Service Bulletin

Bulletin No.: 16-NA-118

Subject: Engine Wiring Harness Chafing, No Start or Malfunction Indicator Lamp (MIL) ON

ECM Mounting Bracket Stud (1) and Corner of ECM (2) Contact Area

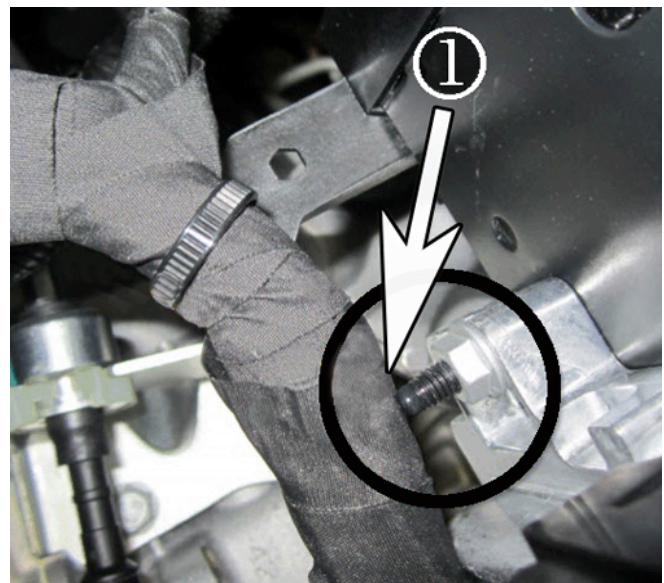
Involved Region or Country	North America
Condition	Some customers may comment on various conditions such as; no start, Malfunction Indicator Lamp (MIL) ON, and possible loss of steering assist.
Cause	Technicians may find the engine harness routed too close to the ECM lower mounting bracket stud or the corner of the ECM. The stud or corner can pierce the harness, and chafe and short wires inside the harness.
Additional Options	Equipped with 1.8L L4 LUW, 1.8L L4 LWE, 1.4L LUV or 1.2L LLO engine

Inspect the harness for signs of contact or damage.
Reroute or repair as necessary.
